MEMORANDUM

DATE: 2	26 September 2024				
		COMPANY: GSJ & 2 LLC	EMAIL:		
c/o Tom Yu		SV Flourishing	svflourishing@gmail.com		
cc: Thad Triplett		SDG Architects, Inc.	ttriplett@sdgarchitectsinc.com		
FROM:	Matthew Hsiung a				
SUBJECT:	640 Lakehaven Drive – Sunnyvale, CA Environmental and Construction Noise Review				
PROJECT:	18-0235

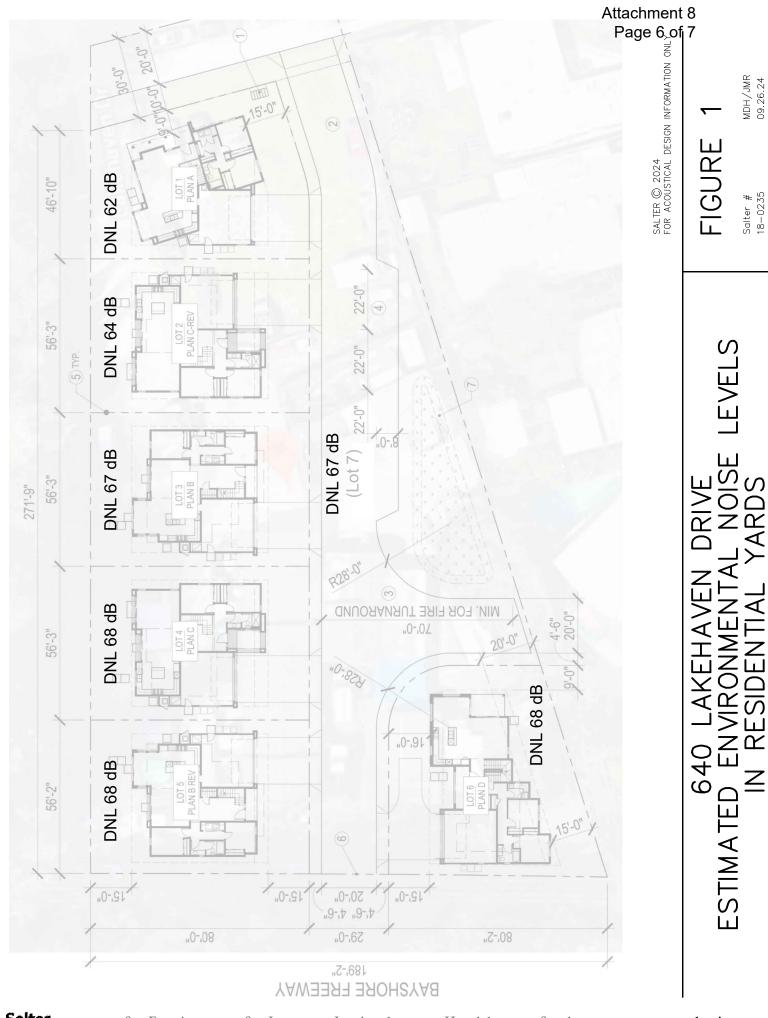
We understand the City has the discretion to approve the project with the estimated noise levels included in Figure 1 with the following considerations:

- The project has oriented rear yards perpendicular to the highway, which increases shielding over what would be expected if the useable open space was located closer to the highway.
- The resulting levels, up to DNL 68 dB, are within the General Plan's "normally acceptable" goal of DNL 70 dB for useable open space in private residential yards of mixed-use projects (i.e., residents will not be exposed to harmful noise levels).
- The neighboring residential site(s) to the east appear to be single family residential with similar exposure to highway noise.
- The project will incorporate noise reduction measures into the building shells to reduce interior noise levels to City goals in sleeping rooms and other habitable spaces.
